Proposed Alternative Text to Clause 154.6

Gary Nicholl, Cisco
John D'Ambrosia, Futurewei, US Subsidiary of Huawei

17 Dec 2020 Joint IEEE P802.3ct / .3cw Task Force Interim Teleconference Meeting

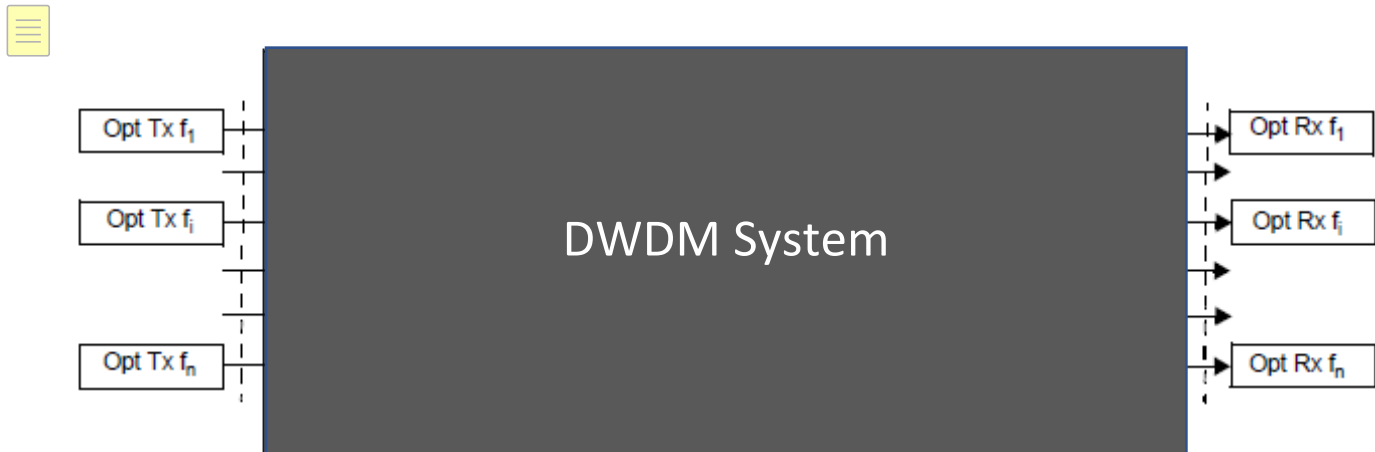
For proper operation the DWDM channel should be configured to the same channel center frequency as the associated 100GBASE-ZR Tx and 100GBASE-ZR Rx .

Specifications are provided for the DWDM channel (from TP2 to TP3, in Figure 154-2), such as chromatic dispersion, ripple, polarization mode dispersion, etc. These specifications are applicable to each of the specified 48 DWDM channels and are defined in a way that the effects of other DWDM channels, simultaneously present on the DWDM system, have been taken into account.

The optical interface parameters of the transmitter of the DWDM PHY are specified at the input of the DWDM channel (TP2 in Figure 154–2). The optical interface parameters of the receiver are specified at the output of the DWDM channel (TP3 in Figure 154–2).
